DEVELOPMENT REVIEW BOARD - **HYDROLOGY SECTION**

DRB Project Number: 2019-002807 Hearing Date: **05-04-2022**

Project: Sunset Memorial Park Agenda Item No: **10**

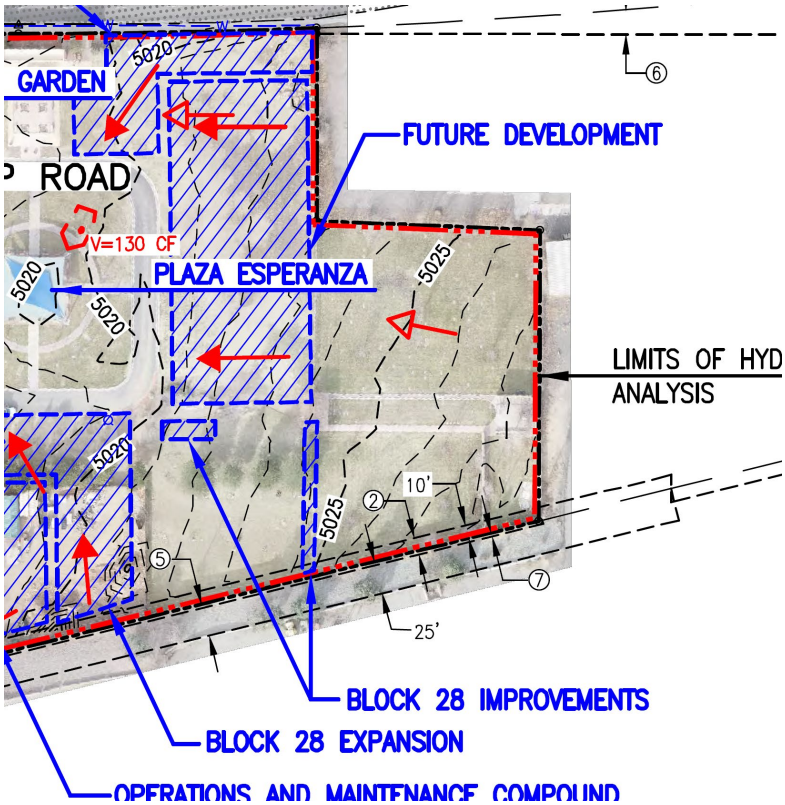
- Hydrology will need either a Grading & Drainage Plan or a add a Cross Lot Drainage Easement note specifying the beneficiary and maintenance agreement.
- Per the Revised Master Drainage Plan (H15D016) with engineer's stamp 03/09/20, the proposed Tract 1B drains into Tract 1A.
